**Decision Document
GAMBELL FORMERLY USED DEFENSE SITE
F10AK0696
St. Lawrence Island, Alaska**

**Declaration Statement
for
Decision Document
Gambell Site F10AK0696
St. Lawrence Island, Alaska**

Proposed Plan for Remedial Action, Gambell FUDS, St. Lawrence Island, Alaska July 2004

Figure 6 – Site 12 vicinity map

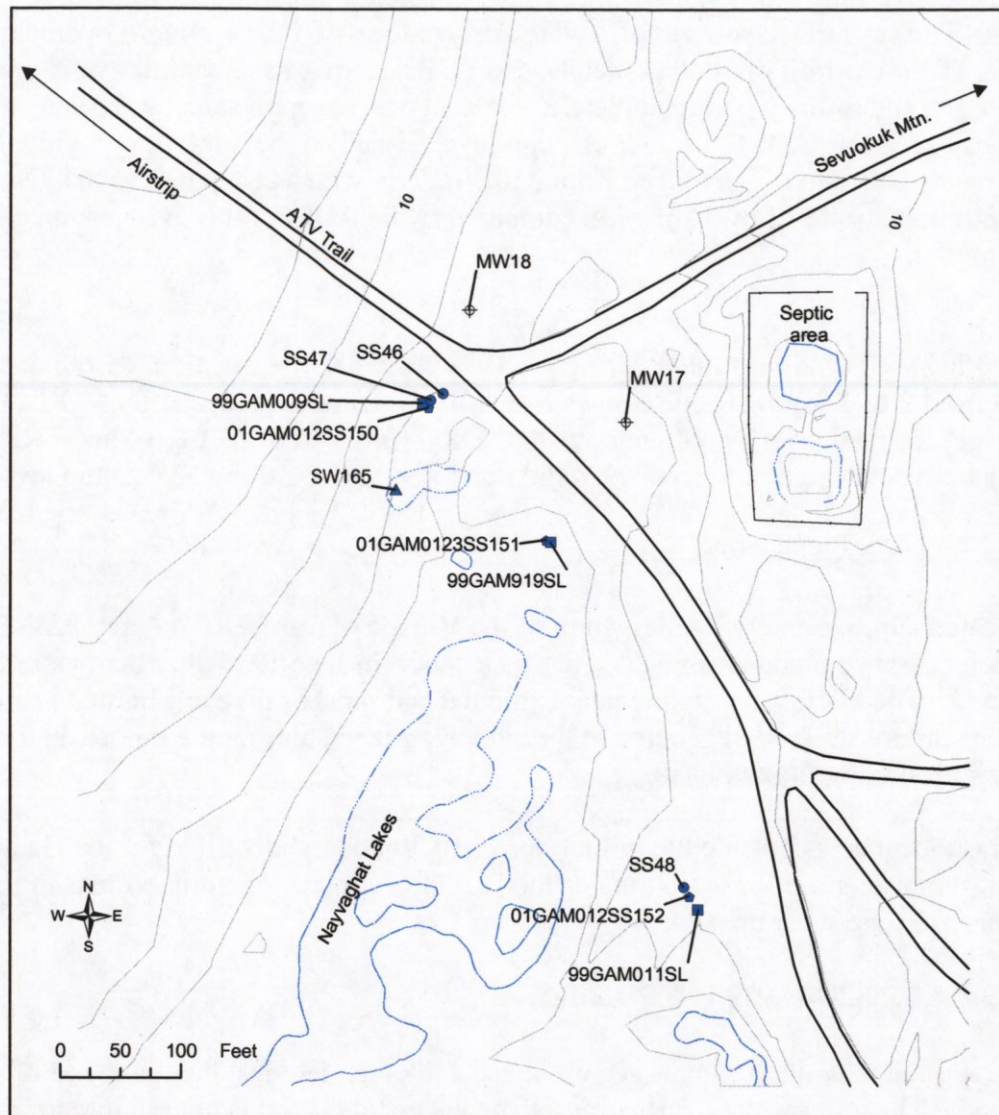
Site 12, p 26. I support the proposed alternative to remove sources of heavy metal contamination. Additional sampling should be done to delineate the full extent of contamination.

Confirmation samples will be collected after the soil is excavated, to verify the contamination was adequately removed.
